# Access Compliance Report

## Public Rights-of-Way

### (Curb Ramps)

Intersection ID: 12504	Main Street: N_BREVARD_ST	Cross Street: E_5TH_ST	Location: W
ADA ID: 23D75AFA26C9	Ramp Type: Directional1	Initial Pass/Fail: Fail	Overall Compliance: No
			Severity Score: 21.25

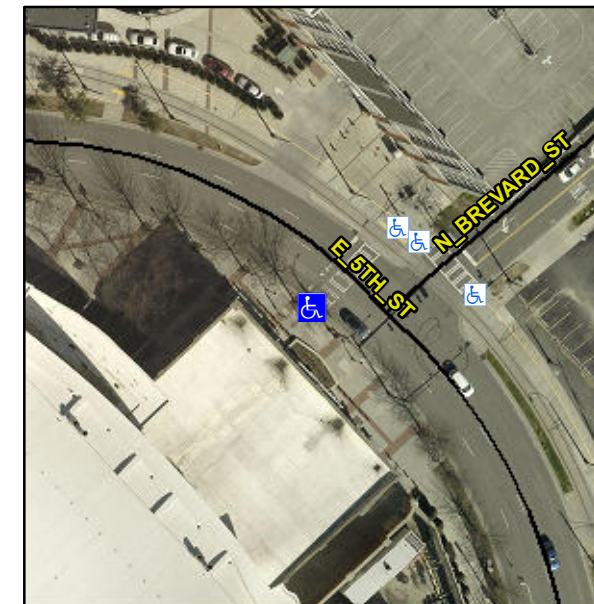
Surveyor Notes:

**PERP**

PROW/ADA:

**R304.5.1, R304.2.2**

Compliance	Description	Data	Compliance	Description	Data
N/A	Ramp Length (in)	68.0	N/A	Grade Break?	N/A
No	Ramp Width (in)	47.0	N/A	Grade Break Slope (%)	0.0
No	Ramp Slope (%)	9.1	N/A	Grade Break XSlope (%)	0.0
Yes	Ramp XSlope (%)	1.2			
N/A	Flare Type LT	N/A	N/A	Flare Type RT	N/A
N/A	Flare Slope LT (%)	N/A	N/A	Flare Slope RT (%)	0.0
N/A	Flare Traversable LT?	N/A	N/A	Flare Traversable RT?	N/A
N/A	Landing Length (in)	0.0	N/A	DWS Provided?	N/A
N/A	Landing Width (in)	0.0	N/A	DWS Contrast?	N/A
N/A	Landing Slope (%)	0.0	N/A	DWS Length (in)	N/A
N/A	Landing X Slope (%)	0.0	N/A	DWS Full Width?	N/A
N/A	Landing Curb? (Y/N)	N/A	N/A	DWS Offset LT (in)	N/A
N/A	Shared Landing?	N/A	N/A	DWS Offset RT (in)	N/A
N/A	Gutter Ponding?	0.0	N/A	Gutter Slope (%)	N/A
N/A	Gutter Lip Ht (in)	0.0	N/A	Gutter X Slope (%)	N/A
N/A	Painted X Walk1?	Yes		Road Slope (%)	2.9
	X Walk 1 Direction	To NE		Road X Slope (%)	0.8
	X Walk 1 Width (in)	104.0		Clear Space?	N/A

Possible Solutions:

**Remove & Replace Entire Ramp.**
